SHOP DRAWING REVIEW
CUNLIFFE & ASSOCIATES

PROJECT
TURNBULL SCHOOL MUSIC ROOM ADDITION

DRAWING TITLE
FOOTING

DETAILED BY J.DOE
SCALE NTS
CONTRACT NO. CP9667F
P1

FOUNDATION PLAN
1:1

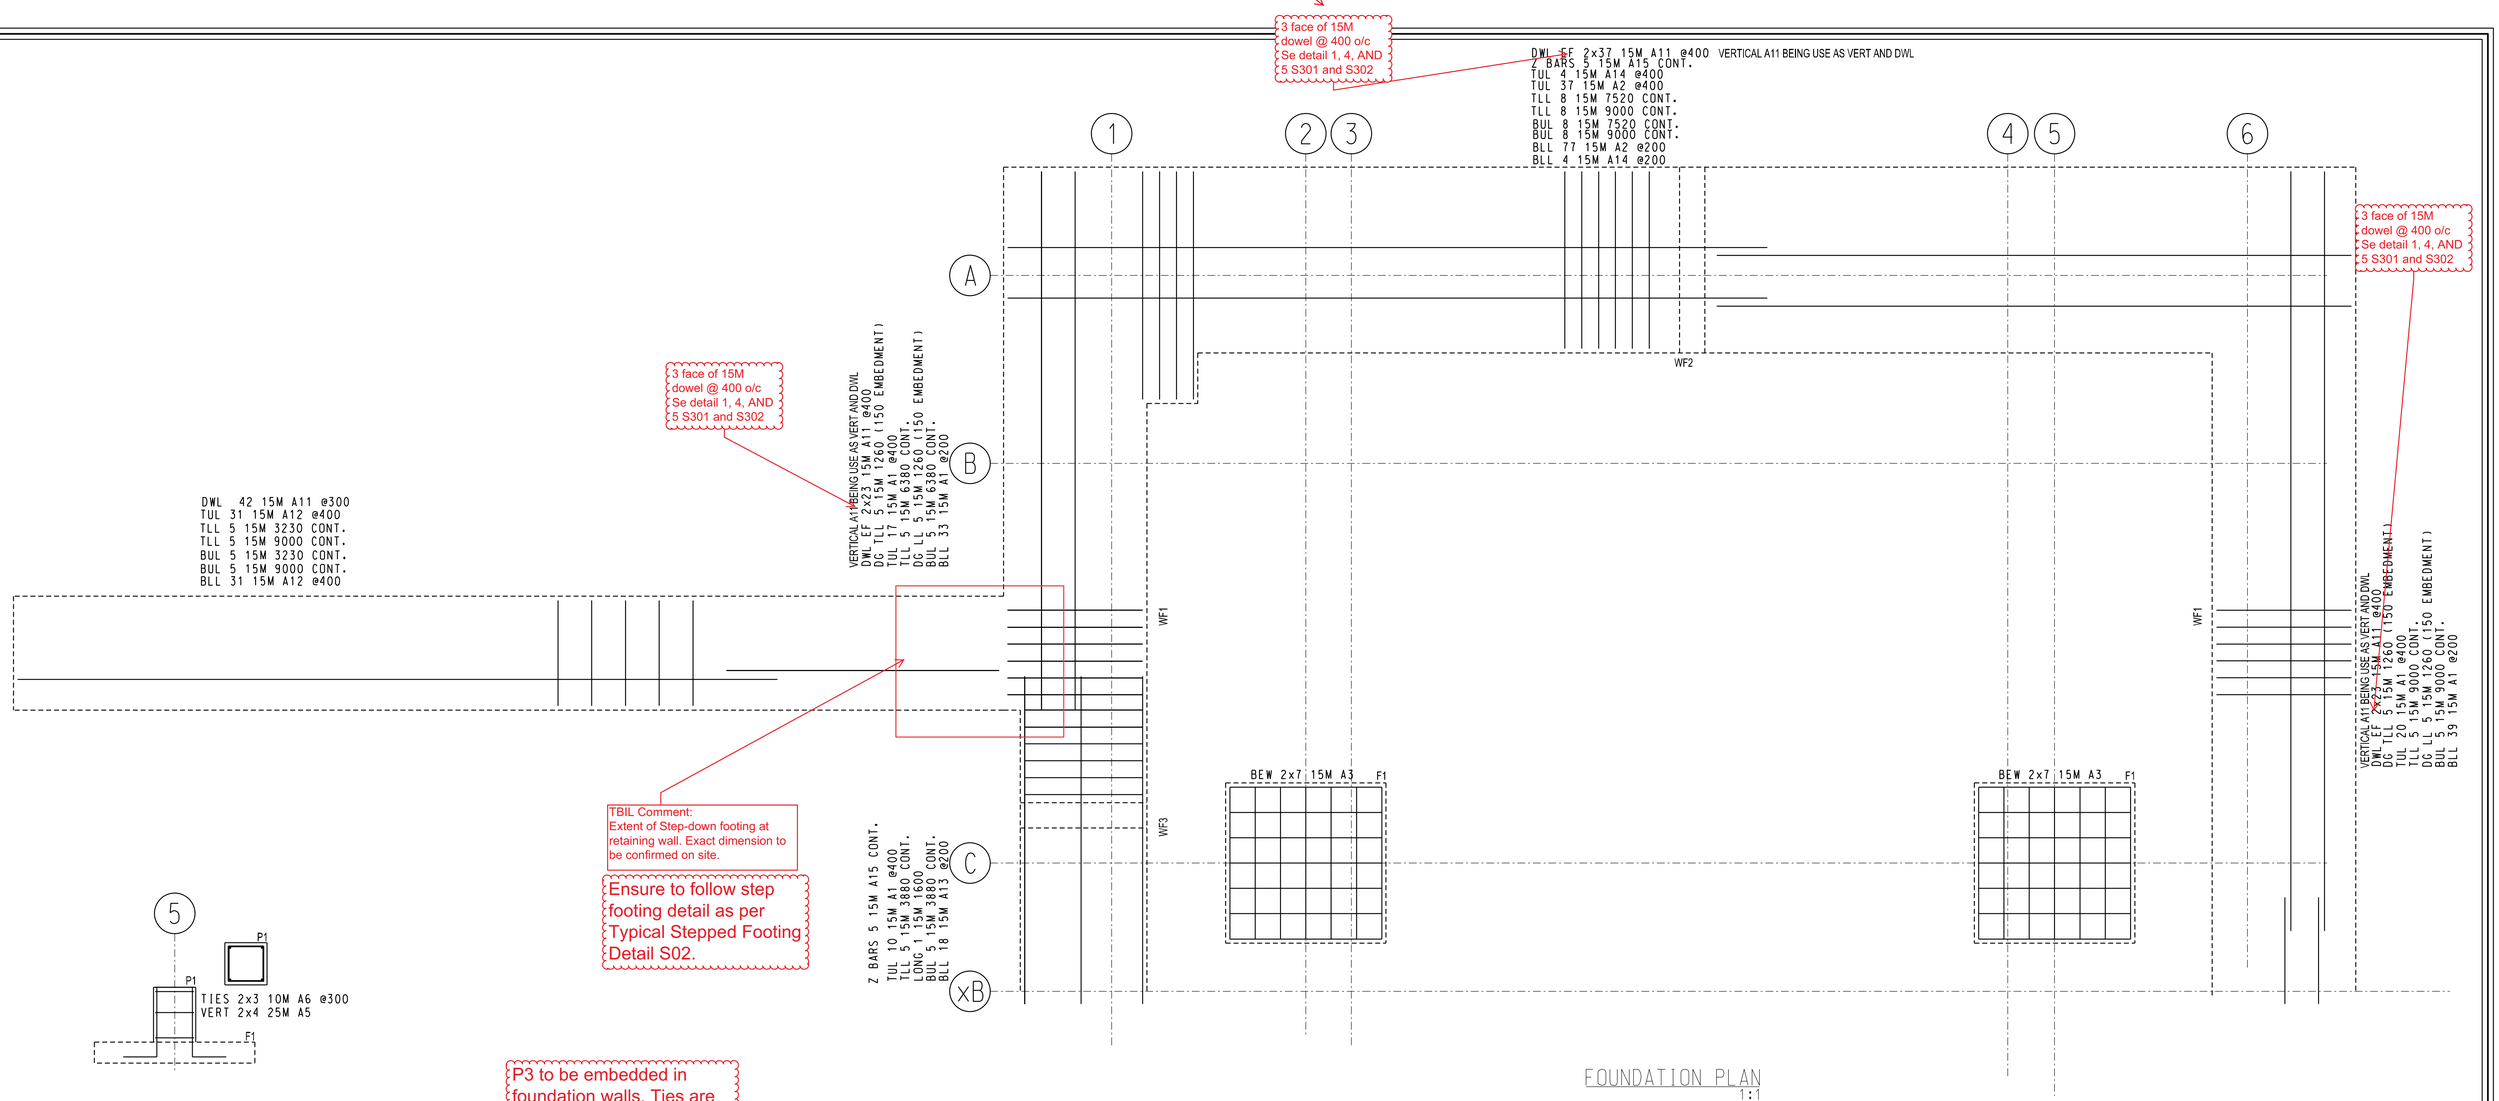
P3 to be embedded in foundation walls. Ties are not required

FOUNDATION PLAN
1 : 1

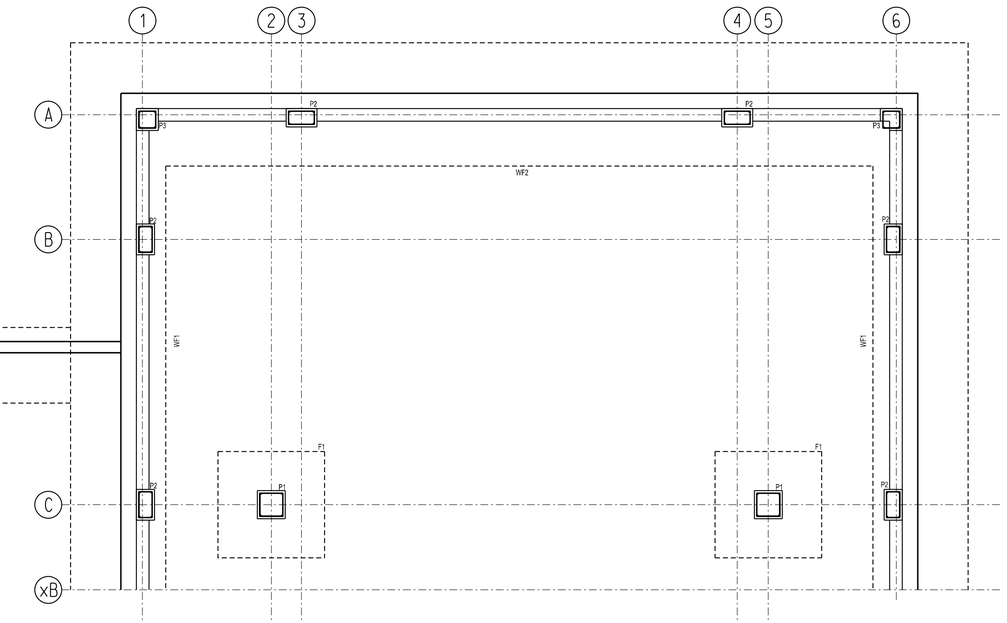
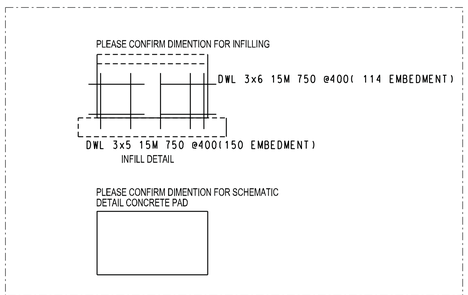
Ensure to follow step footing detail as per Typical Stepped Footing Detail S02.

TBIL Comment:
Step Down footing at Grid 1 side due to site services interference.
